UNION CARBIDE CORPORATION
METALS DIVISION

Subject: Uravan Tailings Ponds 2 and 3 - File No. 11206

March 11, 1982

TITLE ADDITIONAL TRANSVERSE DRAINS - POND 3

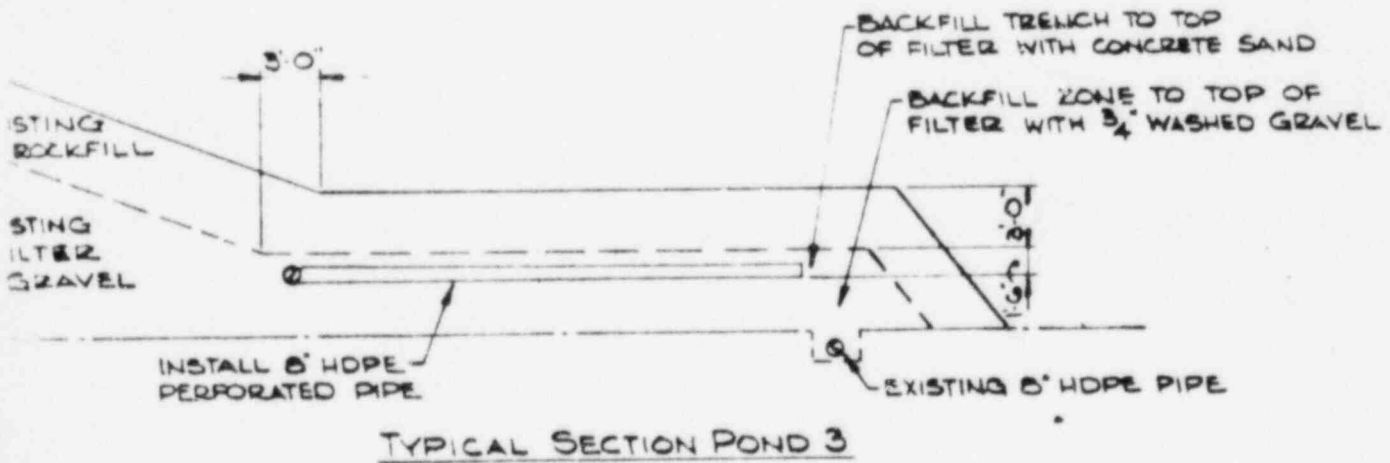
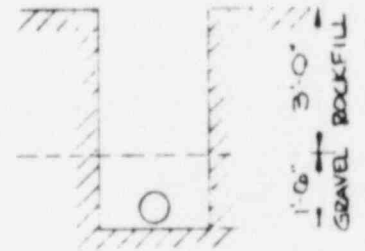
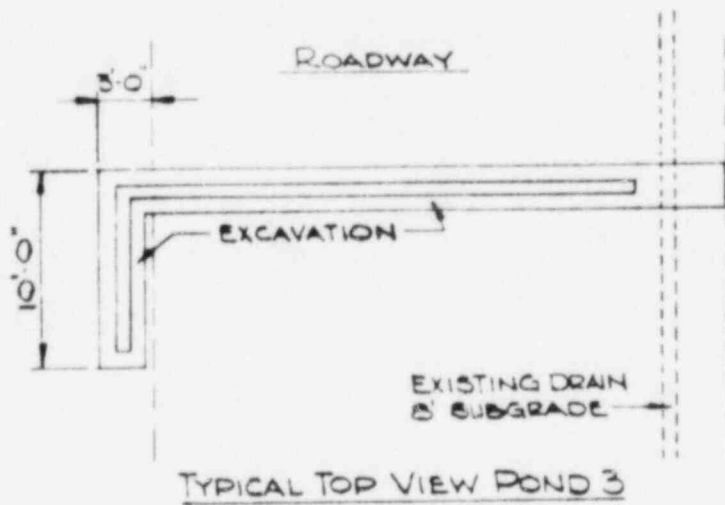
Item (b) noted some minor seepage exiting at several places along the toe of the berm at Pond 3. Dr. Castro suggested installing a transverse perforated pipe to increase the flow capacity within the drainage layer. Our consultants, Acres American Inc., recommended the scheme shown in sketch SF-7835 which differed from Dr. Castro's by having the transverse pipe end near but not be connected directly to the drain pipe. Mr. John Berry of Acres American discussed this change with Dr. Castro and it was agreed that the modified installation would be satisfactory. There were six transverse drains installed along the toe of the berm for Pond 3.
